IMPORTANT SAFETY RECALL NOTICE: 16V294
IMPORTANT SAFETY RECALL

RE: **Hale Intake Strainers – NHSTA Recall No. 16V294**

IMPORTANT SAFETY RECALL NOTICE
NHTSA RECALL 16-E027

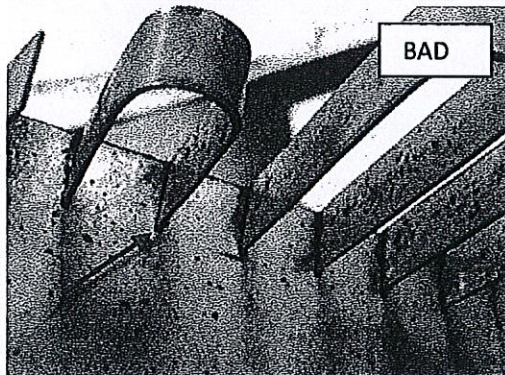
This notice is sent to you in accordance with the National Traffic and Motor Vehicle Safety Act. Hale Products has decided a safety related defect may exist with some 6" intake strainers (010-0030-00-0) that protect the pump from debris in the waterway per NFPA 1901 standards. Strainers shipped between May 2015 and March 2016 may have components that make up the strainer that were improperly soldered during the manufacturing process. This condition could allow the strainer to come apart during use and may allow pieces of the strainer to be drawn into the intake of the pump. This condition could lead to degradation in pump performance which could reduce firefighting effectiveness, potentially leading to personal injury.

As part of your normal daily checks Hale Products is requesting that you pull caps and any suction adapters off of the intake and check the strainer for faulty soldering. To check the strainer simply remove it from the suction with a pair of needle nose pliers and inspect the back side. If your strainer is missing solder at the joint shown below it is considered defective and a potential risk to safe operation.

If you find that you have received a defective strainer please contact Hale Products Customer Service Center at 1-800-533-3569 or halecustomerservice@idexcorp.com and our Customer Service Representative will send a free replacement directly to the station or the address you specify. Please have your pump serial number available for tracking purposes and be prepared to send a picture of the strainer. Since strainer inspection should be part of the normal checks on your apparatus we are not providing warranty coverage for labor.
